Gatwick Airport Northern Runway Project

Design and Access Statement – Volume 3

VERSION: 2.0

SCHEDULE OF CHANGES

Figure 58. North Terminal IDL Extension (South) Indicative Site Context Plan

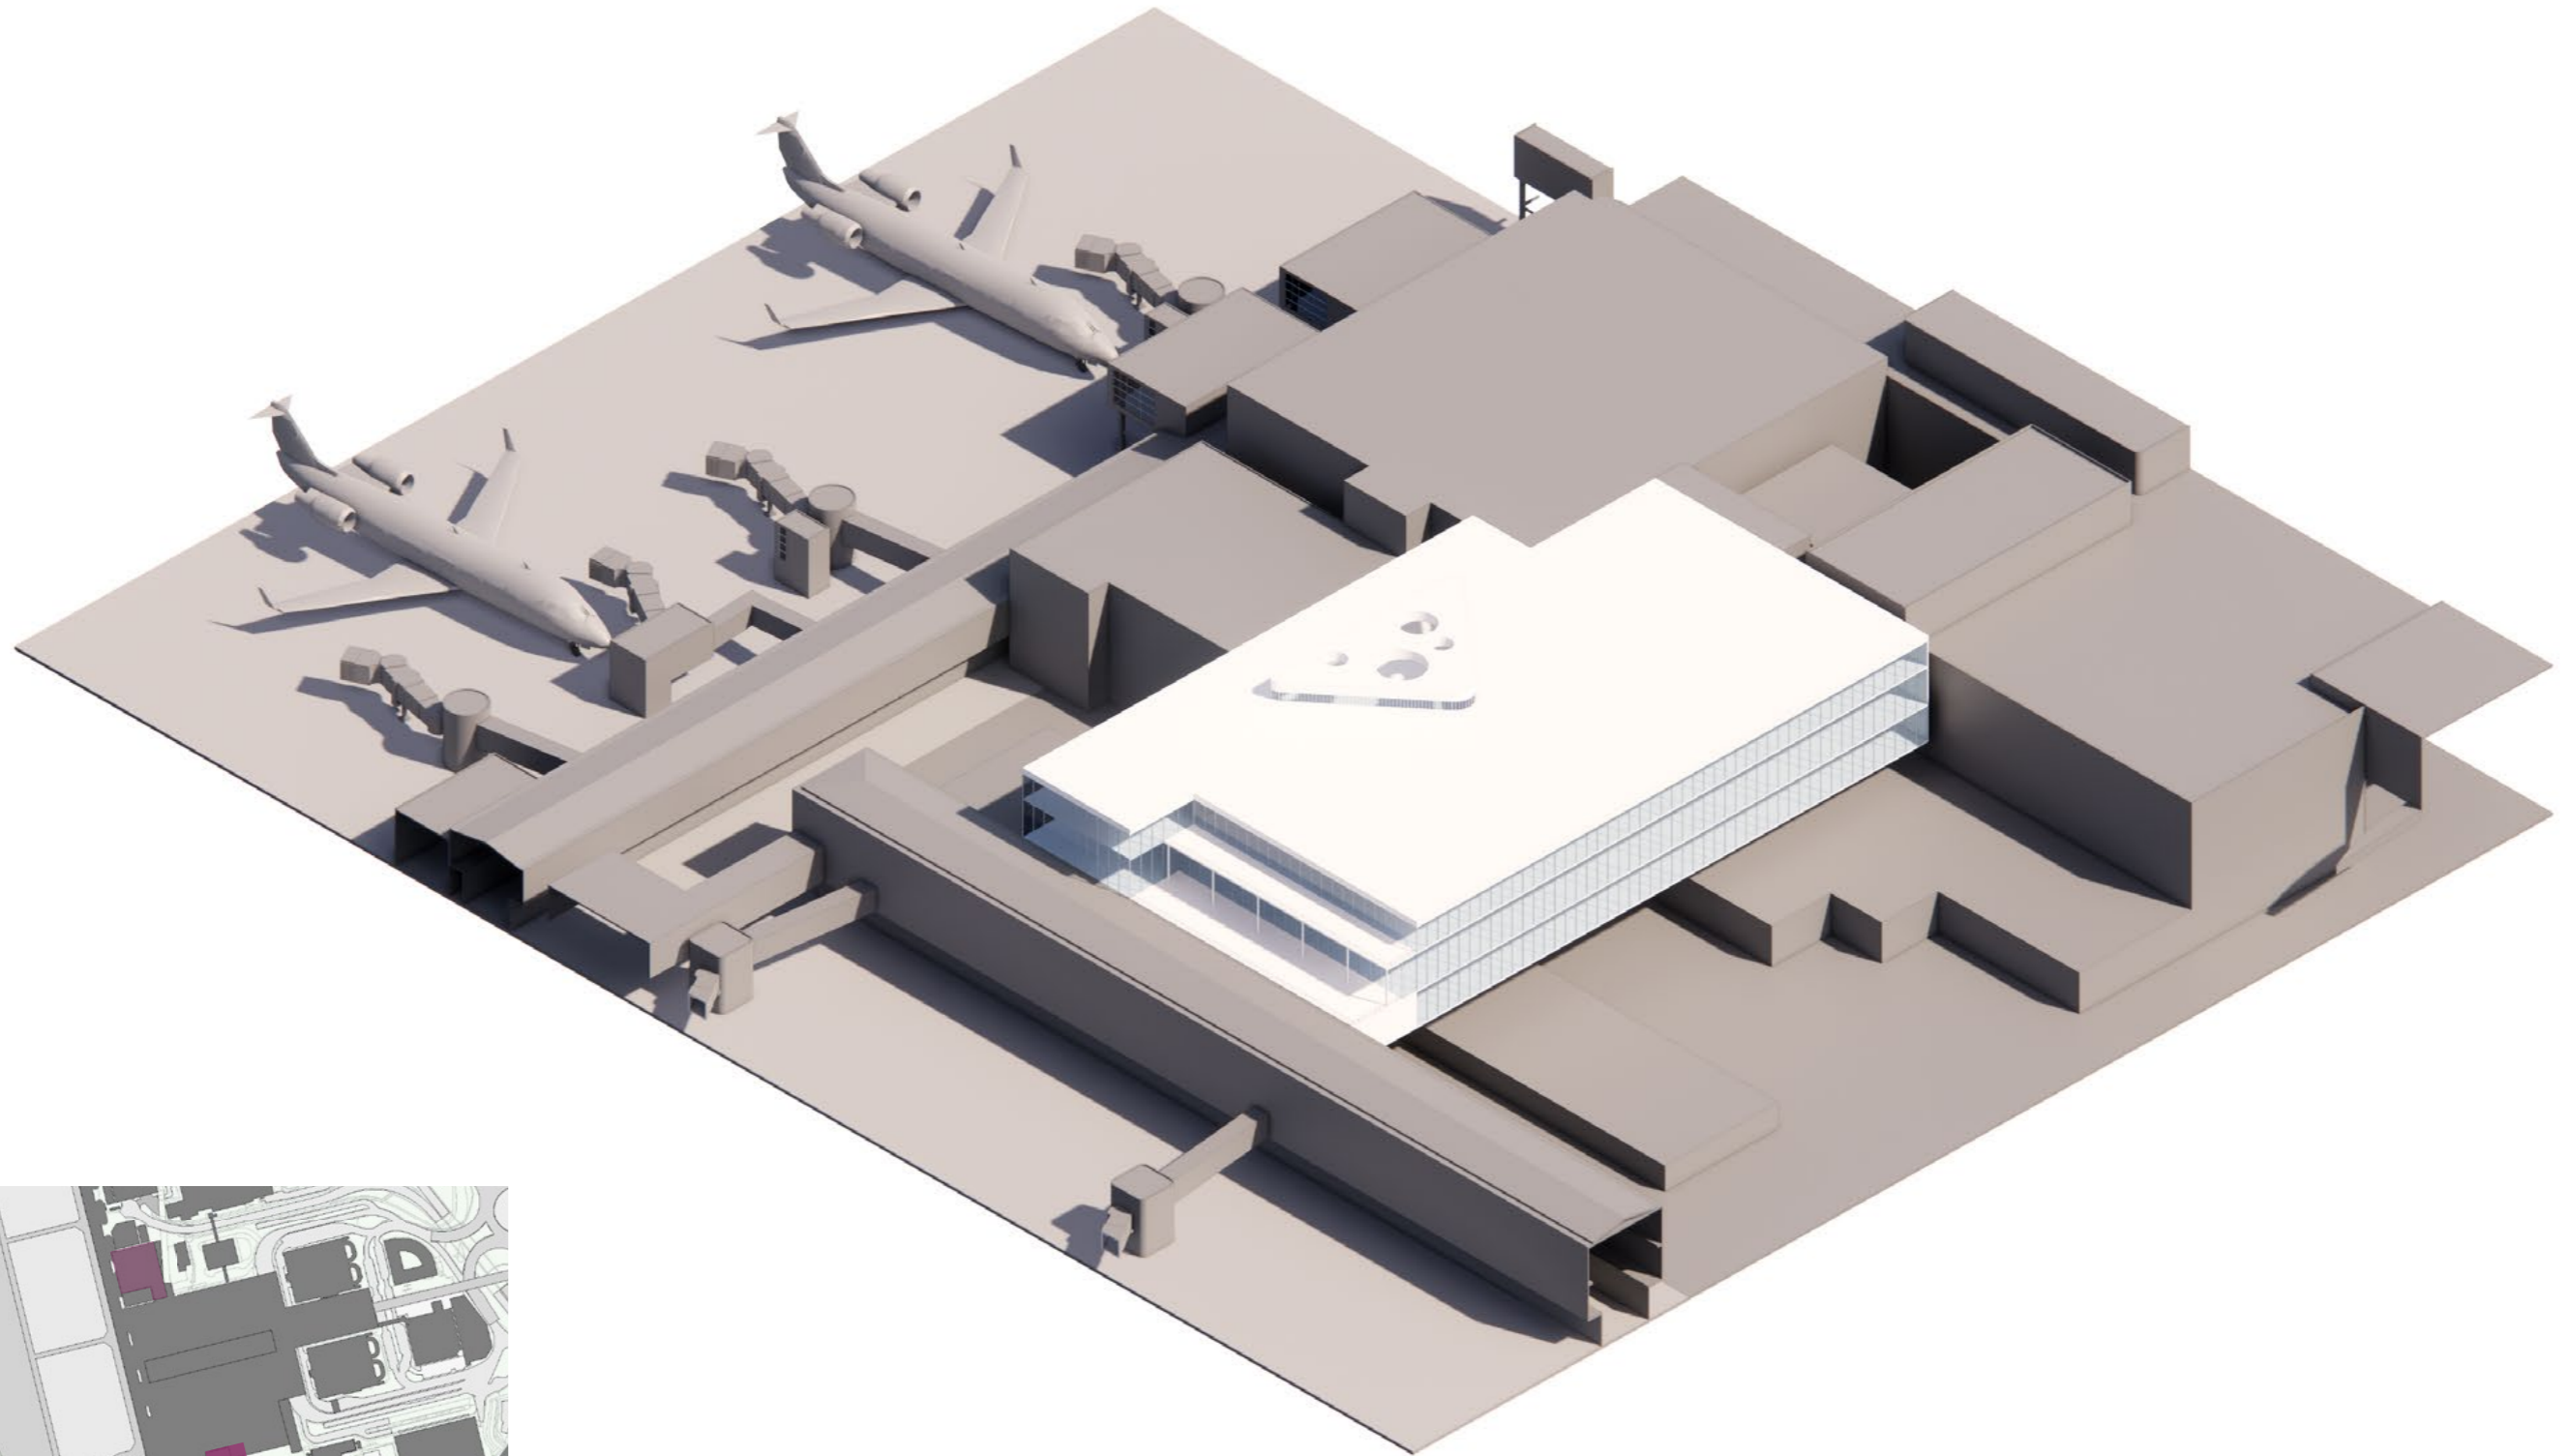
3.17	39	Figure 57	Indicative scope area updated to reflect change to maximum parameter for development.
3.18	40	Figure 58	Figure description updated to include 'Indicative status'.

Figure 83. North Terminal Zone Building Heights

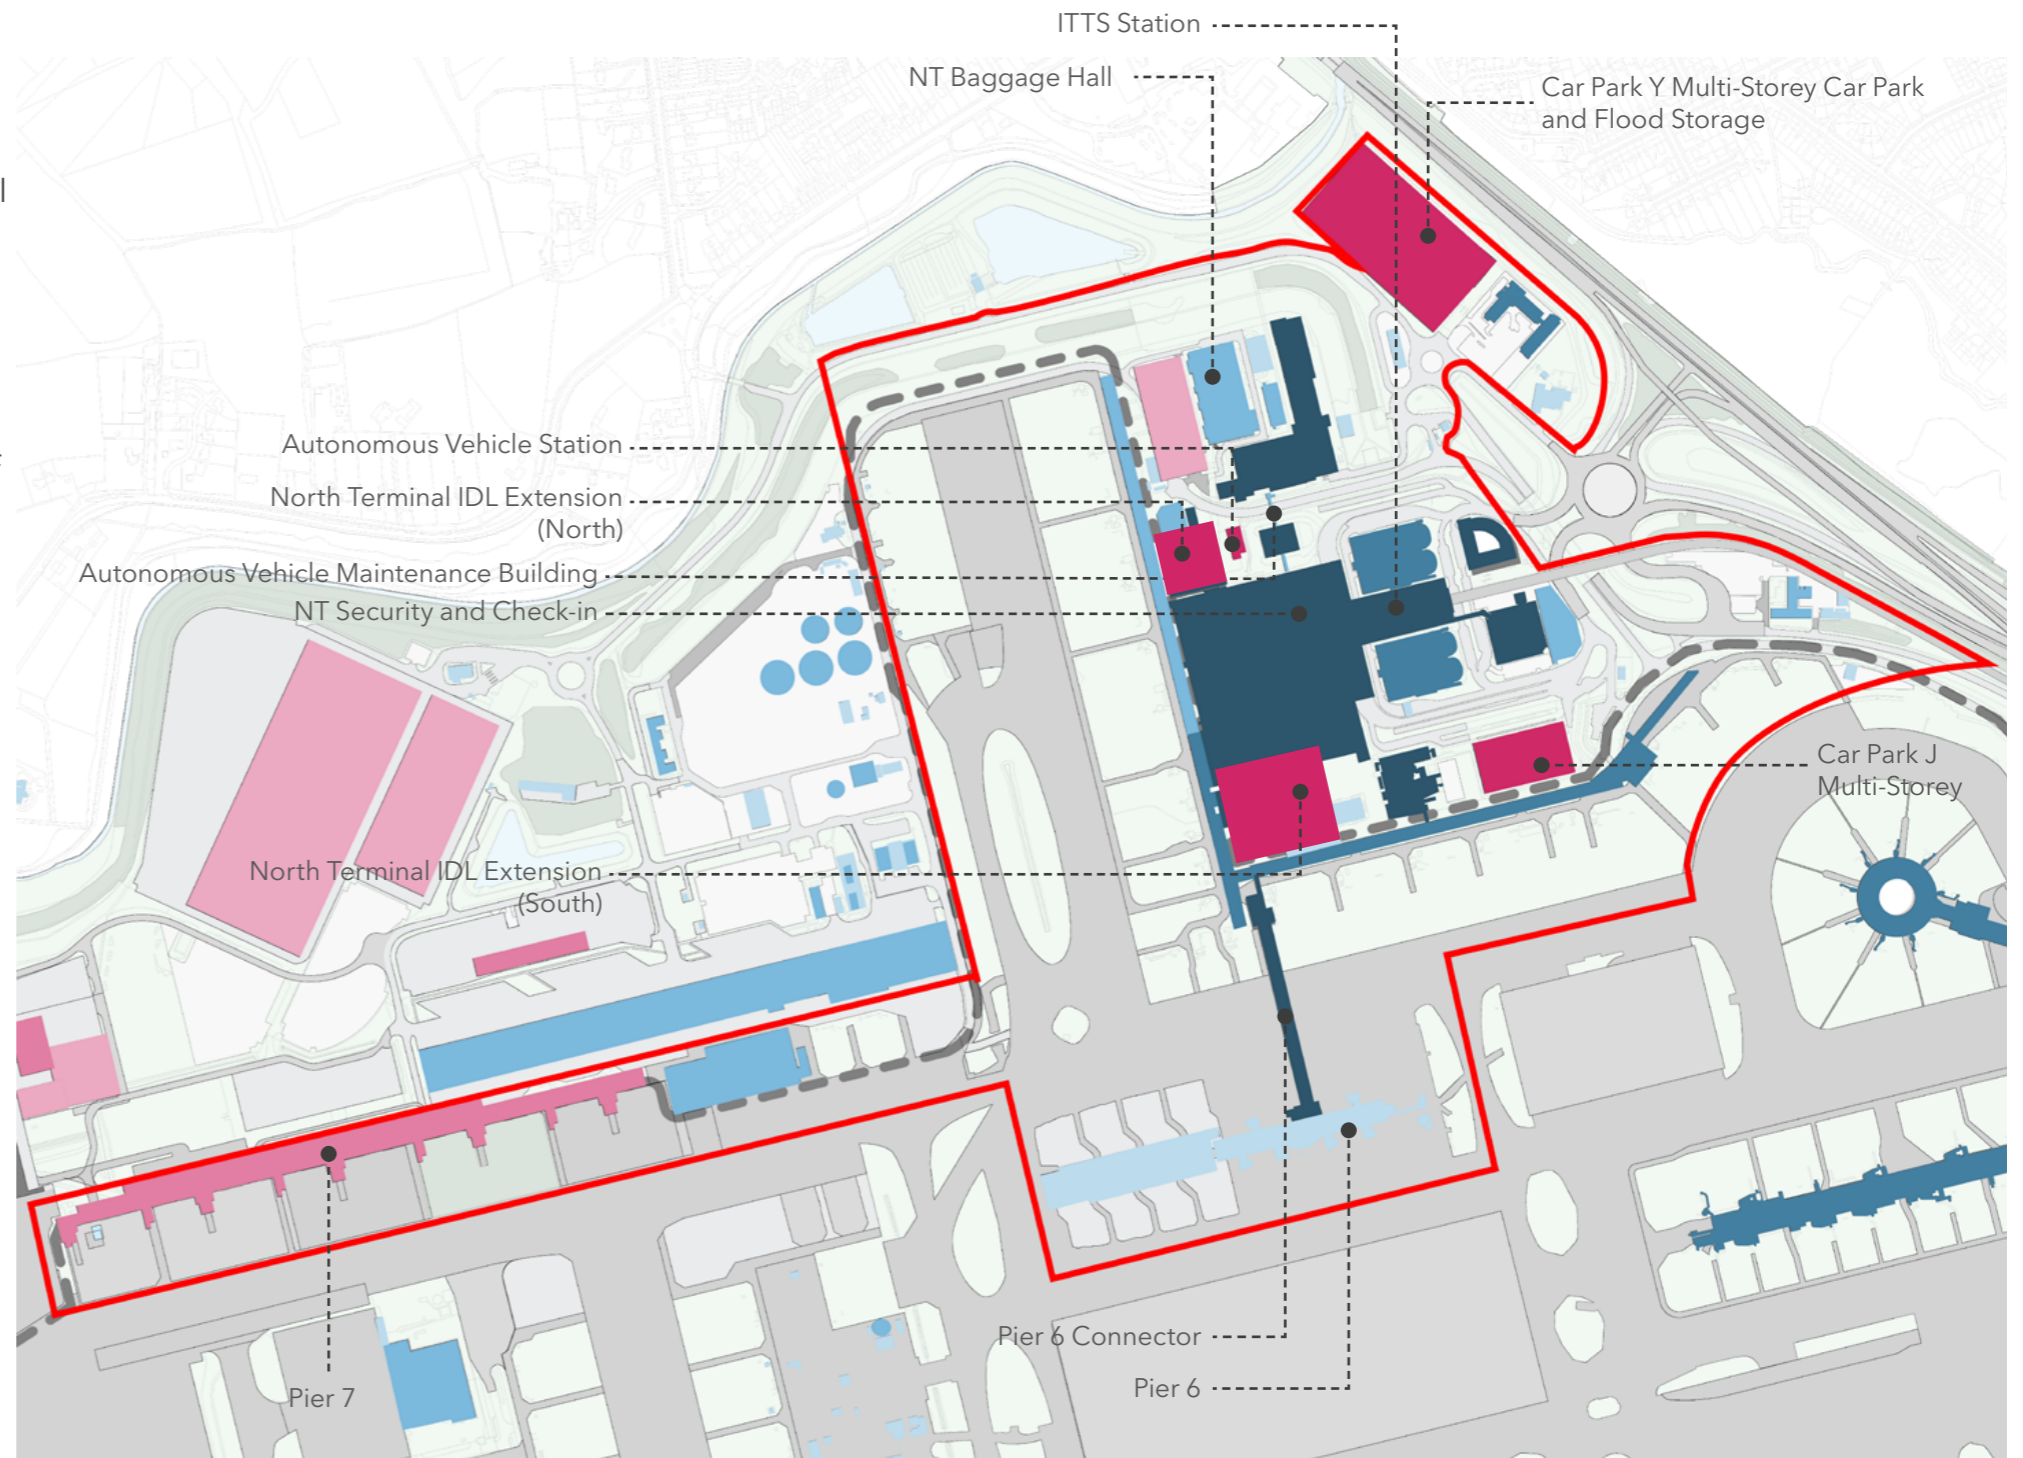
3.19	54	Figure 83	Figure updated to show final phase extent of CARE facility building.
3.20	54	5.7.16	Text changed to reflect change to building parameter as maximum height of 30m above ground level.
